## V2500-A1/A5/D5 SERIES PROPULSION SYSTEMS SERVICE BULLETIN

This document transmits Revision 6 to Service Bulletin EV2500-72-0384

# V2500-ENG-72-0384

ENGINE - LP COMPRESSOR BLADES AND FILLERS - INTRODUCTION OF A REVISED LP COMPRESSOR  
BLADE WITH METCO 58 - REWORK

View of LP compressor blade assembly  
Fig 1

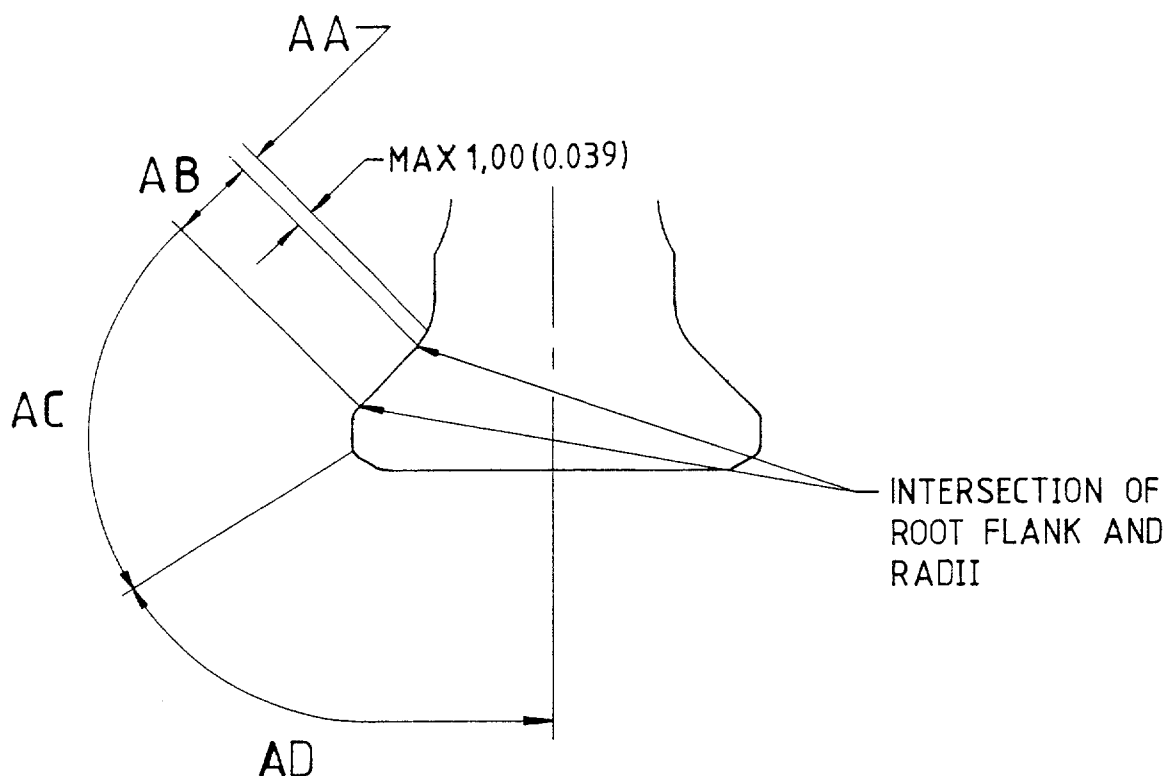
| (1) Remove front and rear chocking pads from blade | Refer to Fig 1<br>Refer to Engine Manual, TASK 72-31-11-300-009, (Repair VRS1022) or<br>Refer to Engine Manual, TASK 72-31-11-300-013, (Repair VRS1028) |
| (2) Remove dry film lubricant from blade           | Refer to Fig 1<br>Refer to Engine Manual, TASK 72-31-11-300-021, (Repair VRS1023) or<br>Refer to Engine Manual, TASK 72-31-11-300-011, (Repair VRS1021) |

- (13) Apply dry film lubricant to blade root  
Refer to Fig 1  
Refer to Engine Manual, TASK 72-31-11-300-021, (Repair VRS1023),  
or  
Refer to Engine Manual, TASK 72-31-11-300-011, (Repair VRS1021)

- (14) Bond chocking pads to blade root
- Refer to Fig 1  
Refer to Engine Manual, TASK  
72-31-11-300-009, (Repair VRS1022),  
or  
Refer to Engine Manual, TASK  
72-31-11-300-013, (Repair VRS1028)

LP compressor blade view at AE  
 Fig 2

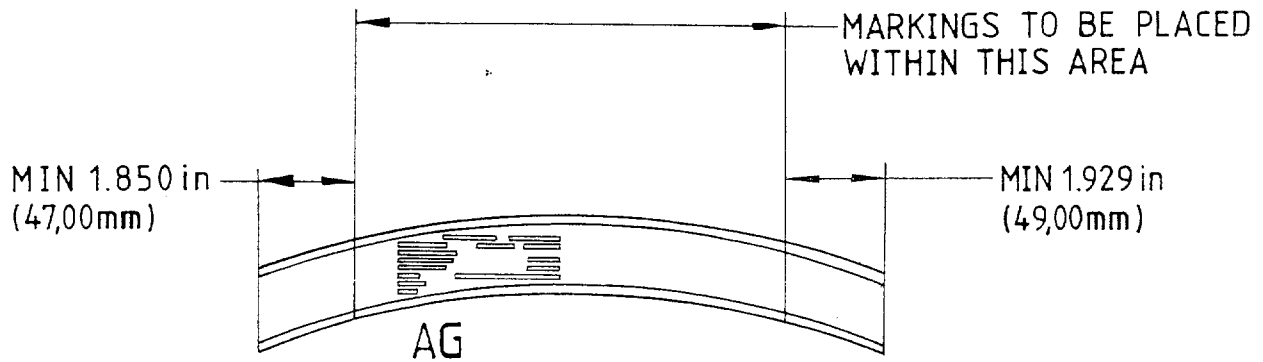
| (5) Visually examine the blade root                                    | Refer to Figs 1 and 2<br>Refer to Appendix 1<br>Refer to SPM TASK 70-21-01-220-501. Visually examine the blade root. Reject if cracked/scarred  |
| (6) Shot peen the blade root   | Refer to Figs 1 and 2<br>Refer to Engine Manual, TASK 72-31-11-300-024, (Repair VRS1723)<br><br><u>NOTE:</u> VRS1723 is a source demonstrated repair  |
| (7) Mask the blade   | Refer to Figs 1 and 2<br>Refer to SPM TASK 70-34-01-340-001. Put suitable masking on the areas not to be abrasive blasted and metal sprayed.<br><br><u>NOTE:</u> It is important to make sure the masking is positioned correctly                                     |

- (8) Abrasive blast the blade  
Refer to Figs 1 and 2  
Refer to SPM TASK 70-34-01-340-001.  
Abrasive blast the area to be metal sprayed at 20 to 25 psi. Use pressure pot abrasive blasting equipment. Keep a nozzle to part distance of at least 76mm (3in.). Make sure the blasting cabinet is thoroughly cleaned and the abrasive medium changed before blasting each set of fanblades (22 off). Use Co-Mat 05-002 abrasive blast media. Use abrasive blasting equipment

- (9) Renew blade masking if necessary  
Refer to Figs 1 and 2.  
Refer to SPM TASK 70-34-01-340-001
- (10) Apply metal spray coating to blade dovetail root working flanks  
Refer to Figs 1 and 2  
Refer to SPM TASK 70-34-01-340-501, SUBTASK 70-34-01-340-005. Use CoMat 03-261 (Metco 58NS) metal spray powder - copper, nickel, indium. Apply the metal spray to a finished thickness of 0,10 to 0,15mm and leave in the 'as sprayed condition'. Use 3R19551 rotating metal spray fixture and test piece holder - 1 off. Use metal spray equipment

- (12) Inspect the metal sprayed coating  
Refer to Figs 1 and 2  
Refer to SPM TASK 70-34-01-340-501, SUBTASK 70-34-01-340-005  
Make sure the metal sprayed coating has been correctly applied. Make sure the thickness of the sprayed coating is within the limits given by measuring the coating thickness on the metal spray test pieces

GRIT BLAST ZONES AA AND AB TO THE INSTRUCTIONS  
 METAL SPRAY TO BE APPLIED TO ZONE AB TO THE  
 INSTRUCTIONS WITH A RUNOUT INTO ZONE AA  
 OVERSPRAY IS ACCEPTABLE WITHIN ZONE AC AS A NATURAL  
 RUNOUT BUT NOT ACCEPTABLE WITHIN ZONE AD

LP compressor blade view at AF  
Fig 3

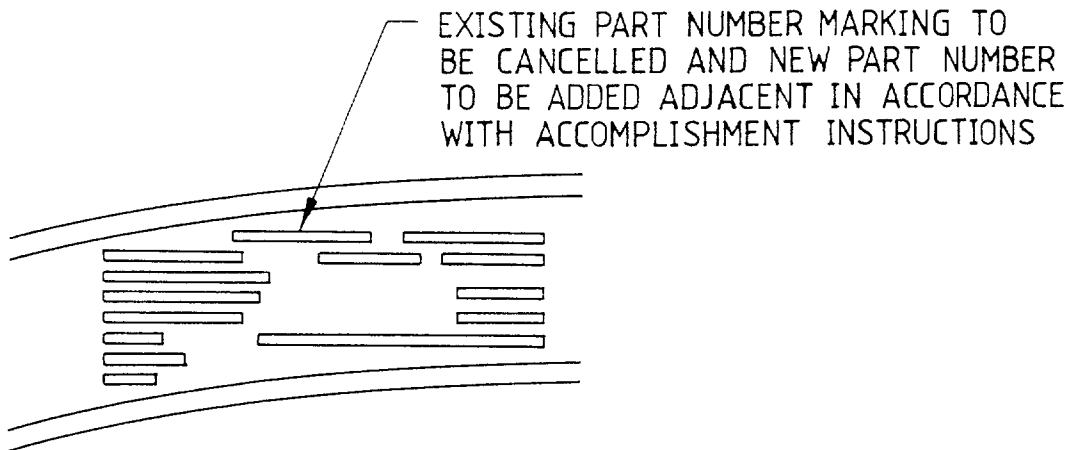
- (15) Re-identify by cancelling the  
existing blade assembly part number  
and adjacent to it mark new  
assembly part number followed by  
the letters 'ASSY'

Refer to Fig 3

Existing	Re-number
6A3494	6A7649
6A3971	6A7650
6A5485	6A7651
6A6519	6A7652
6A7403	6A7653
6A7656	6A7658
6A4700	6A7654
6A6521	6A7655

Area to be inspected  
Fig 7

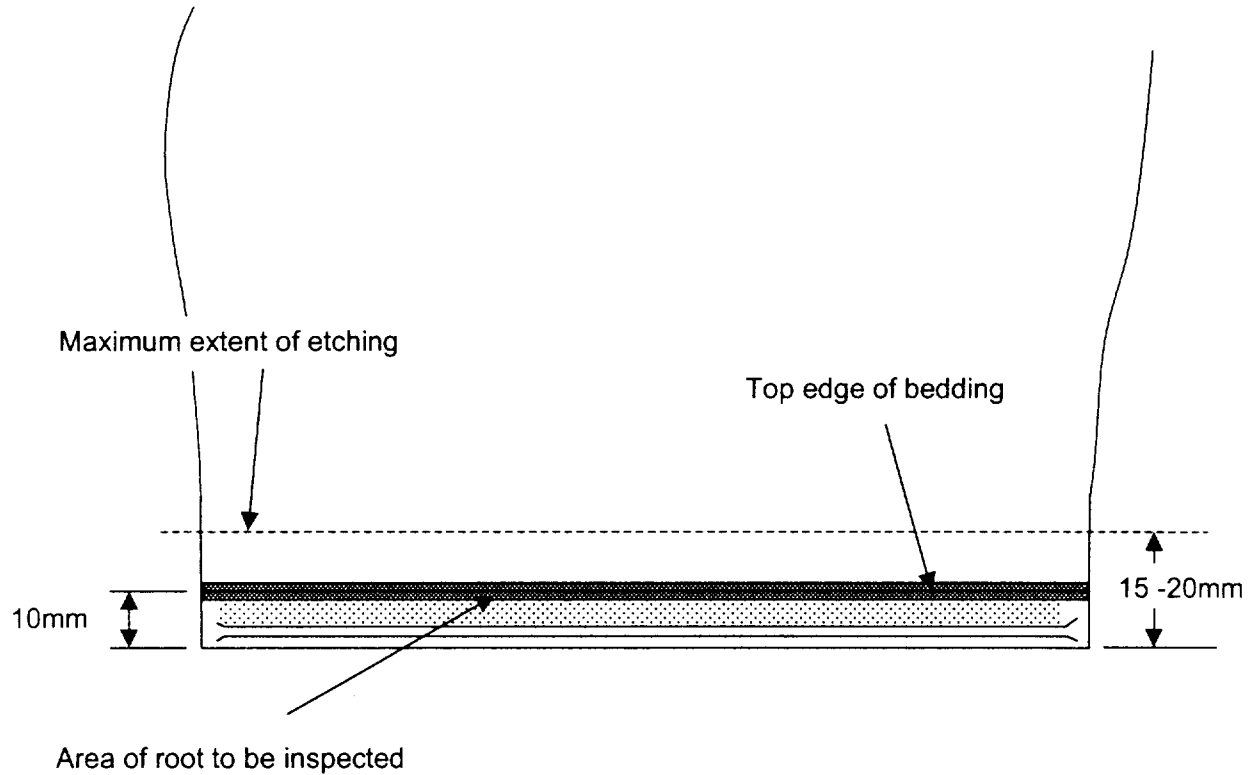
This technique covers the inspection of V2500 fan blade roots for top edge of bedding cracking in the region shown in Appendix 2 Fig 7.

- A. Position fan blade in mounting fixture to view the convex side
- B. Adjust lamp to optimum illumination position for highlighting top edge of bedding, as illustrated in Appendix 2 Fig 7
- C. Set magnification of binocular to x10 and bring the top edge of bedding at leading edge end of the inspected region into focus. Adjust magnification to x30 and refocus if necessary
- D. Slowly traverse along the blade, inspecting the entire top edge of bedding from leading edge to trailing edge as shown in Appendix 2 Fig 7

A. Reject any blade exhibiting a crack like feature running axially along the root in the inspected region

B. Reject any blade exhibiting a 'scar' or crater-like feature
